Drinking Water Audit Report

County:	Donegal	Date of Audit:	21 August 2014
Plant(s) visited:	Rosses Regional PWS (Crolly WTP)	Date of issue of Audit Report:	19 September 2014
		File Reference:	DW2013/88
		Auditors:	Ms Derval Devaney
Audit Criteria:	<ul style="list-style-type: none"> • The <i>European Union (Drinking Water) Regulations 2014 (S.I. 122 of 2014)</i>. • The <i>EPA Handbook on the Implementation of the Regulations for Water Services Authorities for Public Water Supplies (ISBN: 978-1-84095-349-7)</i> • The recommendations specified in the EPA Report on <i>The Provision and Quality of Drinking Water in Ireland</i>. • The recommendations in any previous audit reports.

Photo 4 Poly being dosed in contact tank prior to clarifiers

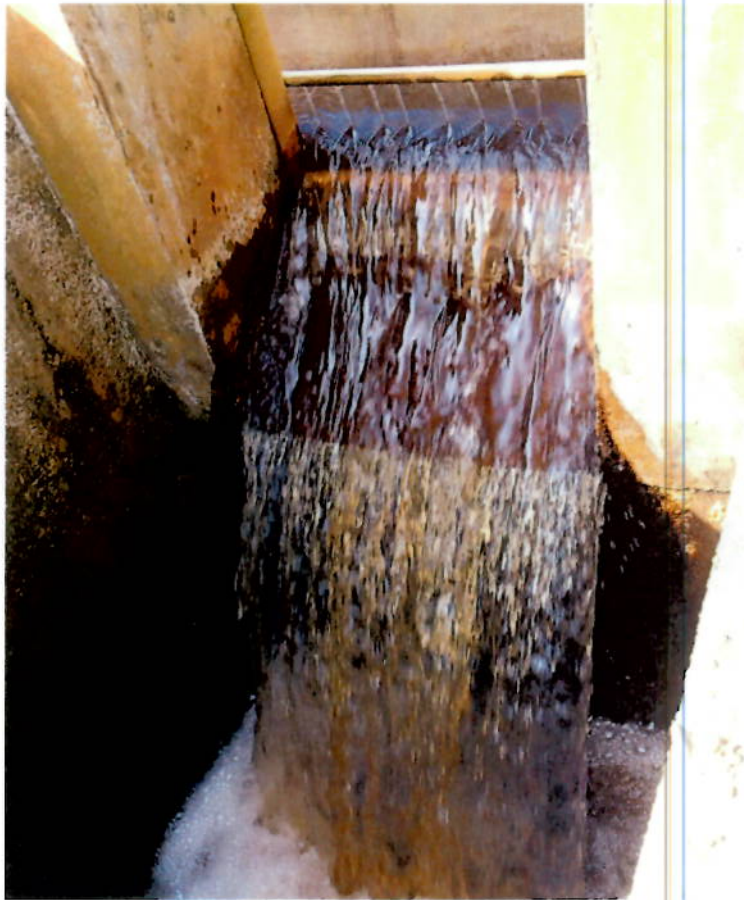
2.	<p>Coagulation, Flocculation and Clarification</p> <ul style="list-style-type: none"> a. The combined flow is dosed with soda ash at ~ 34 mg/l to adjust the pH and is then dosed with liquid ferric aluminium sulphate (Chemifloc 101) at ~ 150 mg/l prior to contact tank. Poly aluminium chloride, 0.1 % strength, is added (at ~ 0.186 mg/l) upon water exiting the contact tank approximately 5 minutes later (see Photo 4). b. Concern regarding the high cascade directly post addition of poly was expressed by the auditor and the possibility of any floc already formed breaking up due to the aggressive nature of the mixing this cascade induced (see Photo 5). c. There are 3 no. clarifiers (2 No. flat bottom installed in 1978 and 1 No. hopper bottom installed pre-1970). The flat bottom clarifiers have an upflow rate of 1.79 m rise / hr and the hopper bottom clarifier has an upflow rate of 0.44 m rise / hr. d. There are turbidity monitors on the combined clarified water from the clarifiers which read 0.63 NTU on the day of the audit. e. Pin floc was observed being carried over to the filters from the clarifiers. f. The sludge bleeds are sent to a lagoon on-site which is divided into 3 cells. One (middle) cell contains this sludge from the clarifiers, one contains backwash water which is pumped to the 3rd cell on the east side of the lagoon. Overflow from the cell with sludge also flows into the 3rd cell. Discharge from the 3rd cell enters the outlet chamber and is discharged to the nearby stream which is monitored downstream of the discharge (see Photo 6). The sludge that settles in the middle cell is transported off-site to Letterkenny Waste Water

1. The Water Services Authority should carry out an investigation to identify the cause of floc carryover from the clarifier into the filters. In this regard the Water Services Authority shall consult Table 2 on Page 41 of the EPA publication "*Water Treatment Manual: Coagulation, Flocculation and Clarification*" and investigate the use and management of polyelectrolyte and pH correction in line with the designed plant's operating procedures. The cascade system in place post addition of poly should be investigated to ensure it does not result in the break-up of flow post clarification.
